Proposal: 2-4 Giffnock Avenue, Macquarie Park

Application No: SSD-79017211

In response to the City of Ryde Council comments dated 5 February 2026 under Stormwater comments section, we are pleased to provide you with our response below:

Integrated Water Management Plan

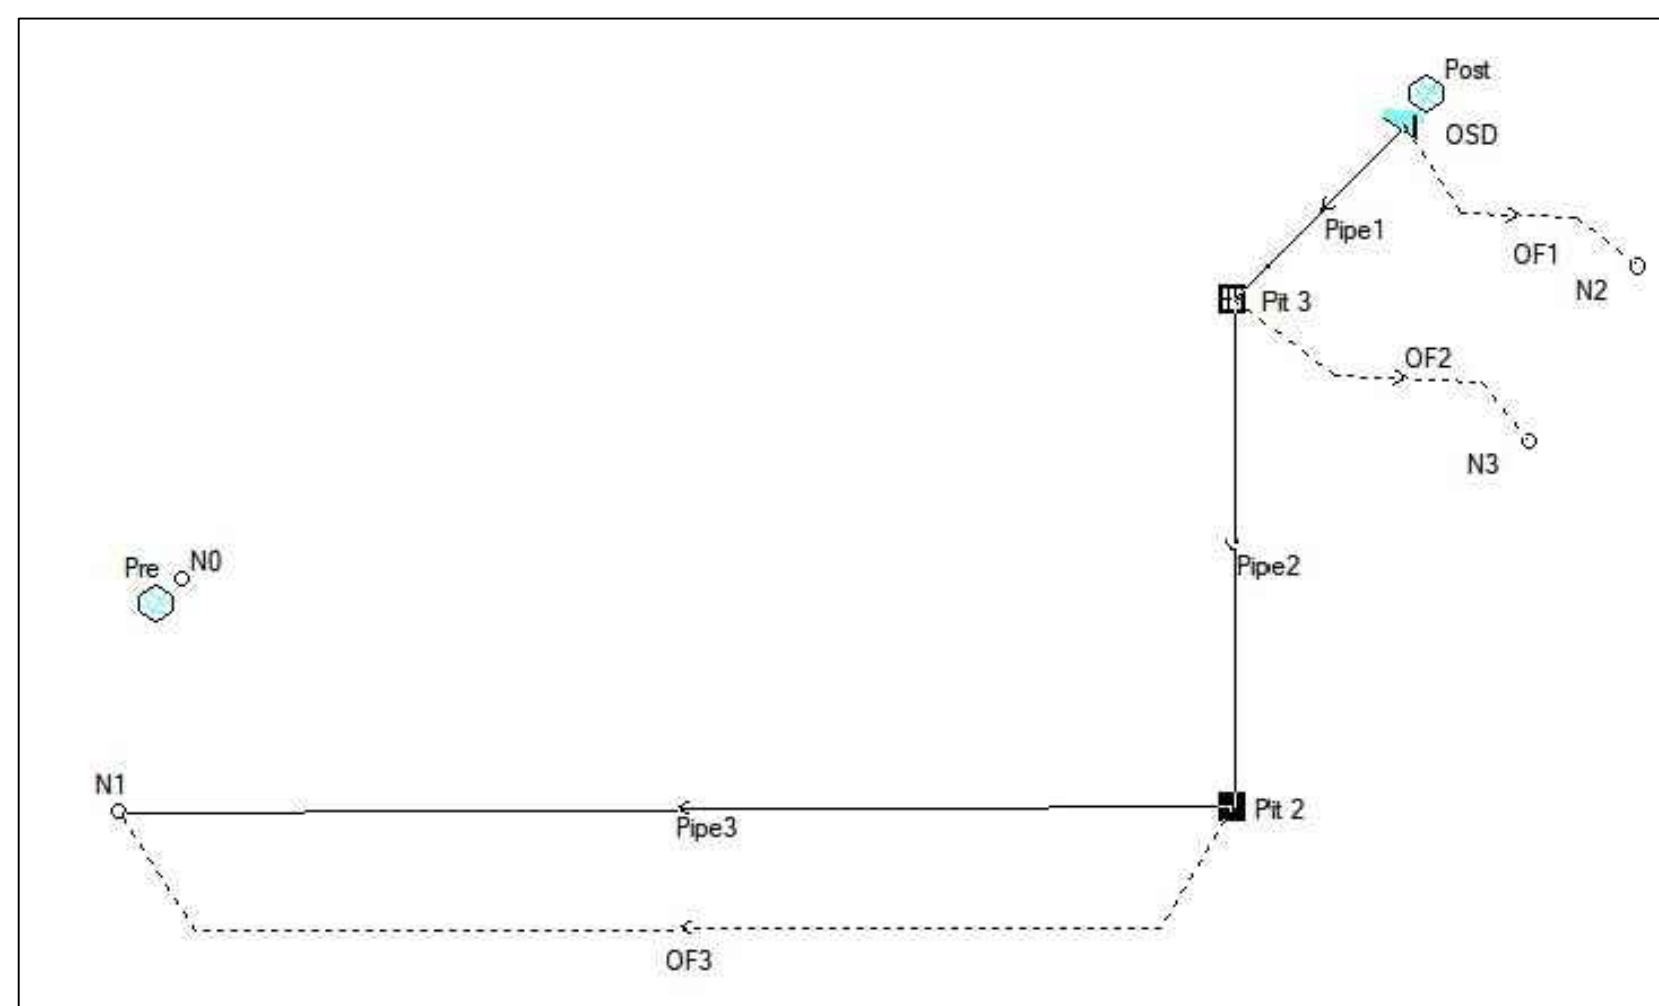
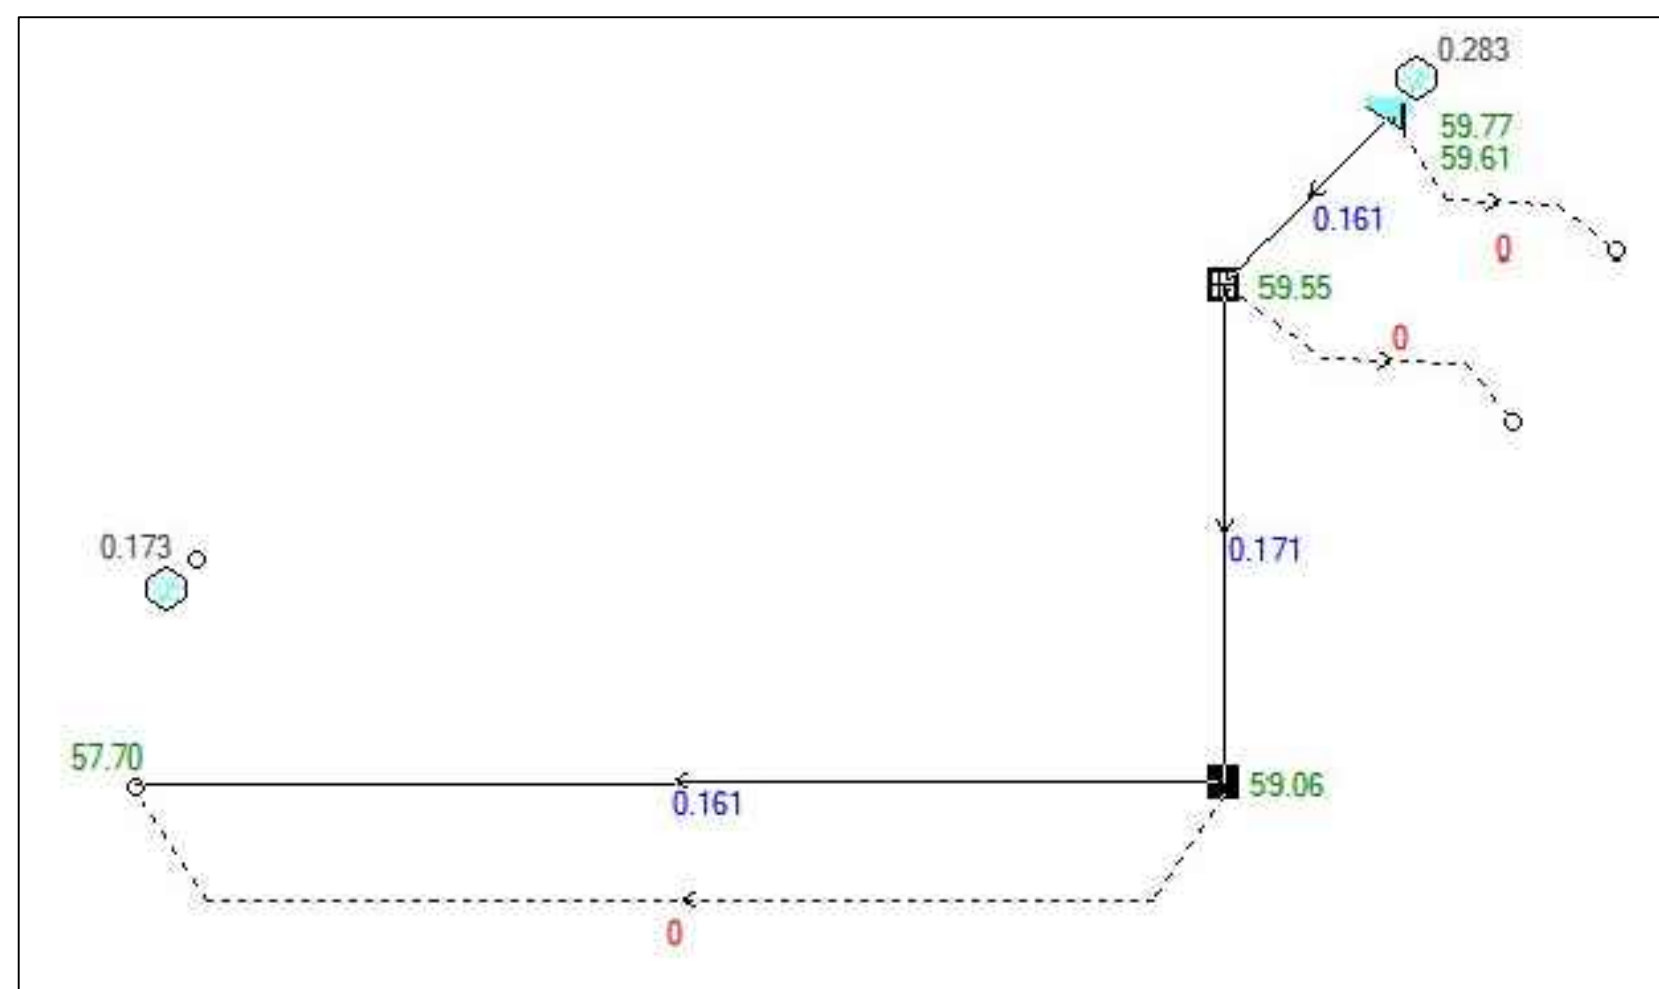
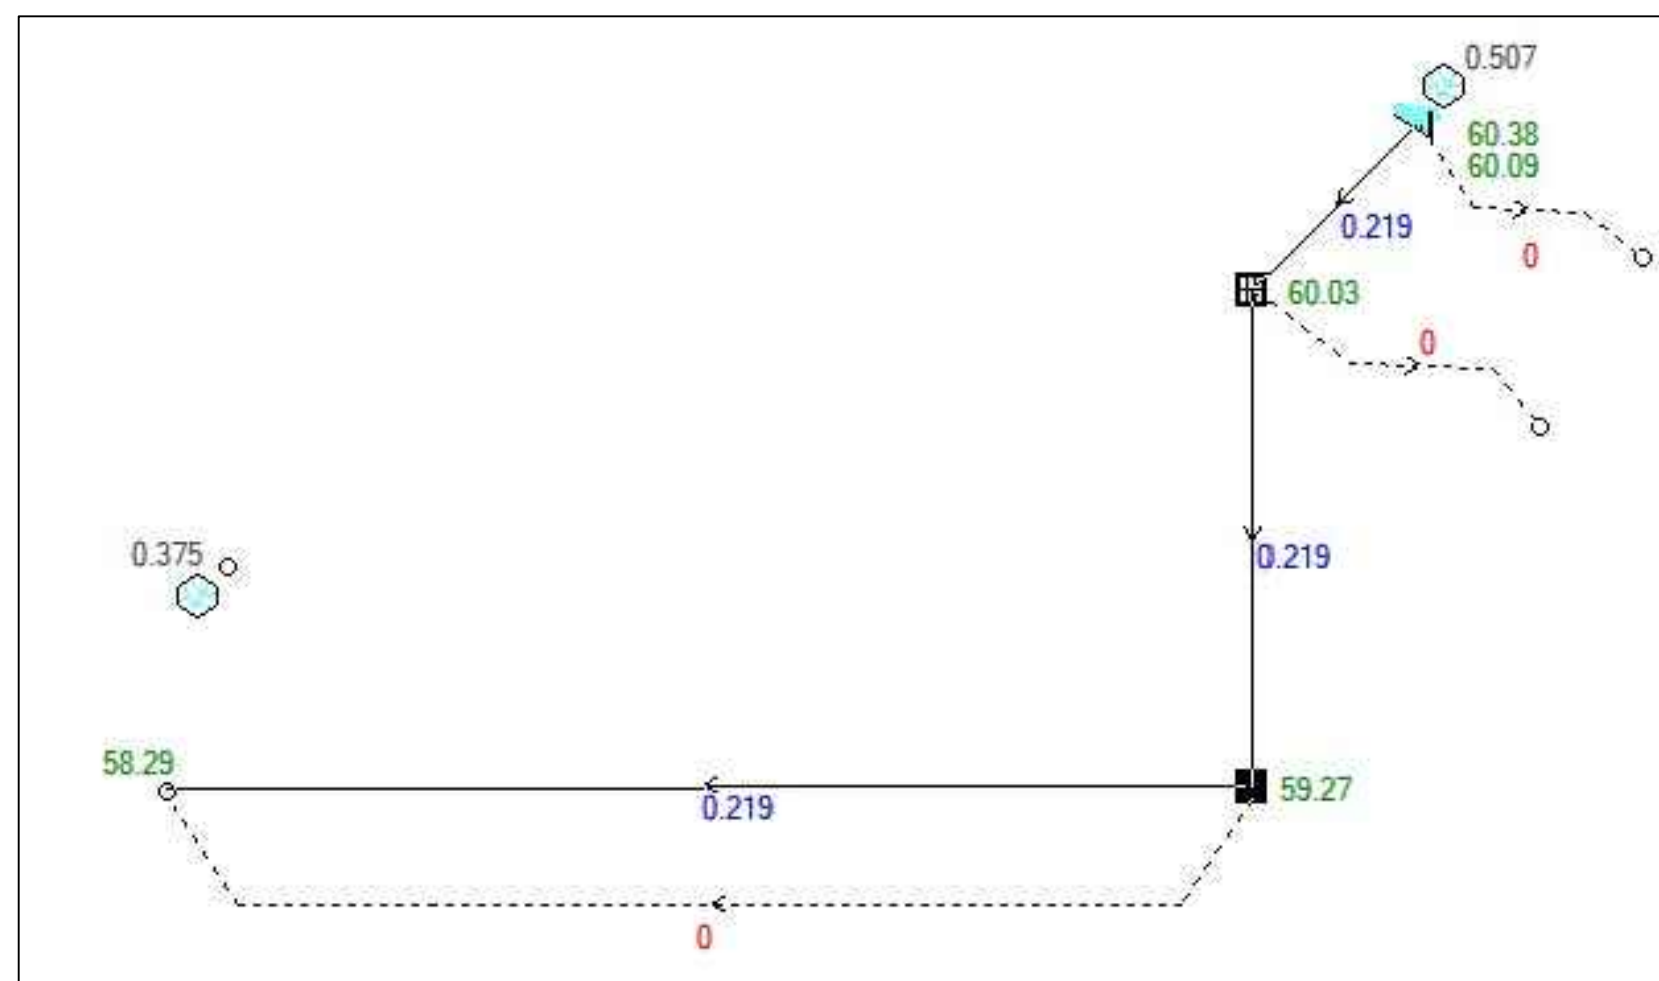
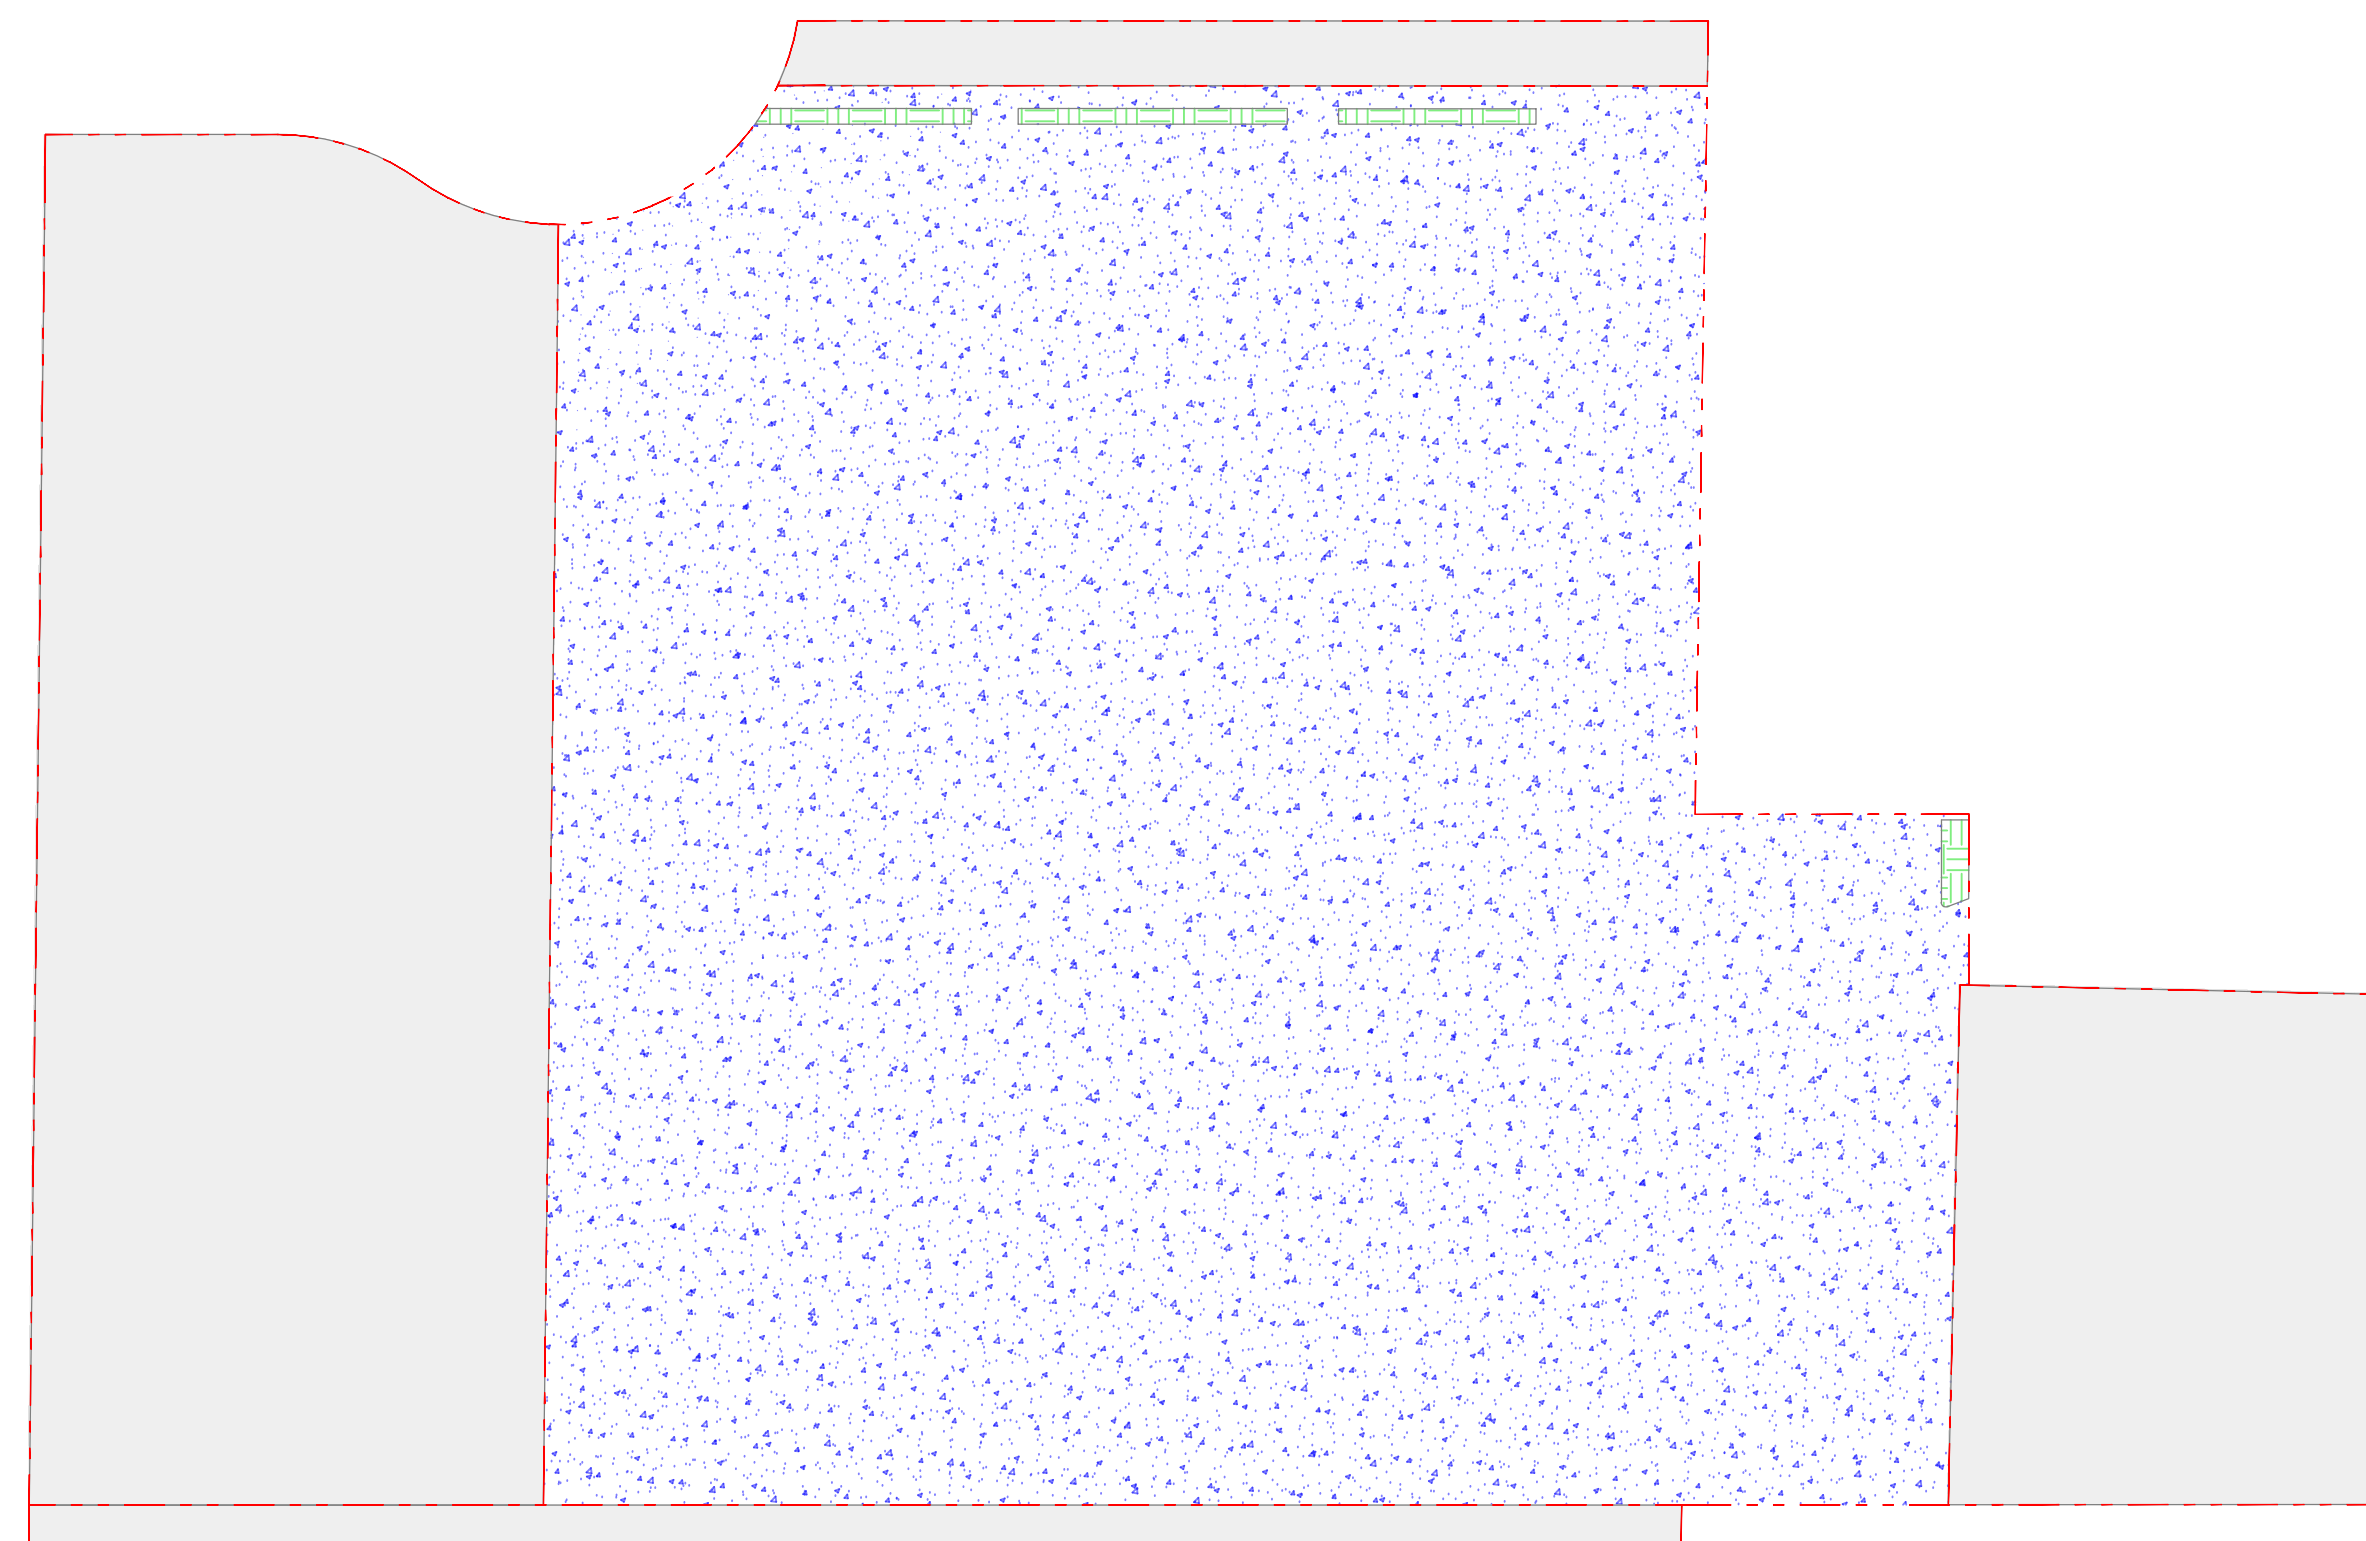
No	Comment	Consultant Response
10.a.	The OSD analysis has been undertaken utilizing DRAINS software however the data files have not been provided for review. As such, there is no ability to confirm whether the provided OSD design is adequate. Council requests this be provided.	The DRAINS model is provided.
	The stormwater system proposes a 10m ³ rainwater tank which is extremely underwhelming considering the scale of the development. It is pertinent to note that a typical duplex development in the Ryde council area would likely accommodate the same level of storage. The applicant should refer to the DCP Part 8.2 controls and associated documents for guidance on rainwater storage requirements. To be clear the level of rainwater capture is to be increased.	As per the BASIX report for Towers A1 and A2, a 5,000 L rainwater tank is provided and is required to collect rainwater from the building roof area. The same applies to Tower B1. Refer to the BASIX reports "ELAB_BASIX Report_2-4 Giffnock Avenue_A1 & A2_002" and "ELAB_BASIX Report_2-4 Giffnock Avenue_B1_002" for more details.
